**From:** Lasley, Timothy G  
**Sent:** Thursday, July 19, 2018 10:01 AM  
**To:** 'carlae@purplecherry.com'  
**Cc:** Werner, Jeffrey B; Mess, Camie  
**Subject:** BAR Actions - July 17, 2018 - 404 East Main Street

BAR 18-06-01

404 East Main Street; Tax Parcel 280046000

Window replacement (South elevation)

4  
2 Divided Lite - 1 1/8" Muntin SCALE: 6" = 1'-0"

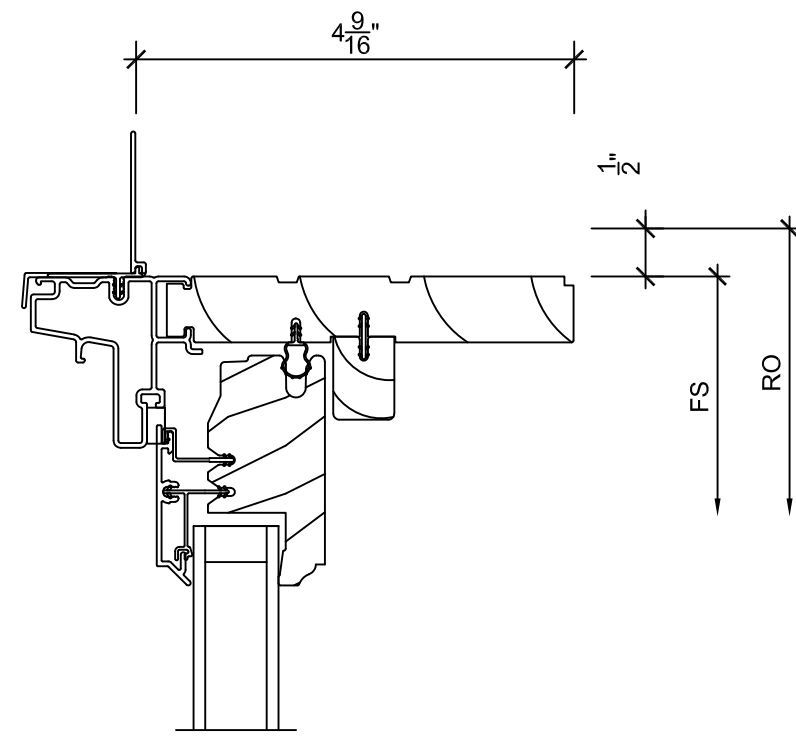
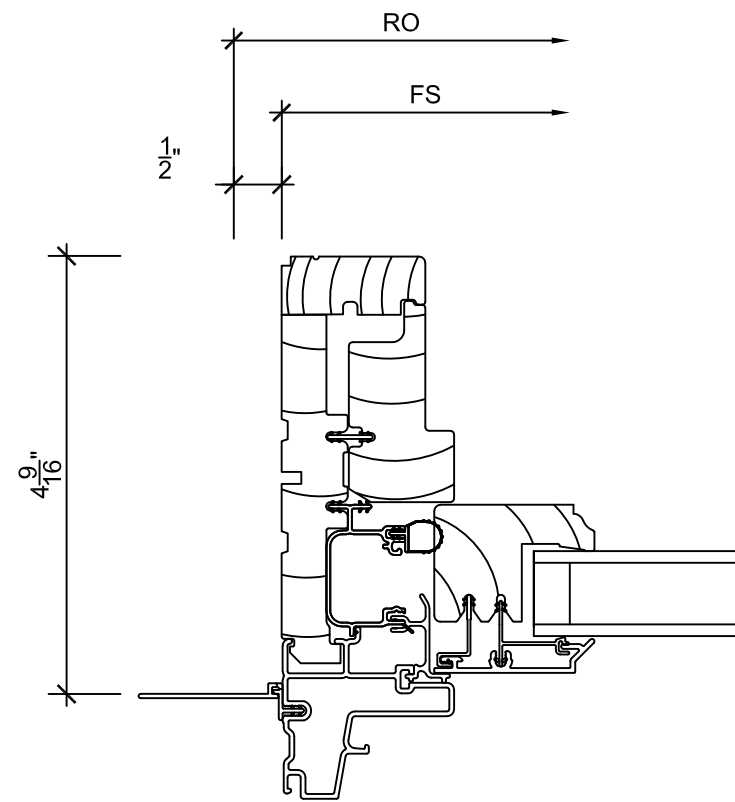
Motion: Schwarz moved having considered the standards set forth within the City Code, including City Design Guidelines for Rehabilitation, I move to find that the proposed window replacements satisfy the BAR's criteria and are compatible with this property and other properties in the Downtown ADC District, and that the BAR approves the application as submitted; windows to have 1-1/8" mullions.  
Balut seconded. Approved (7-0).
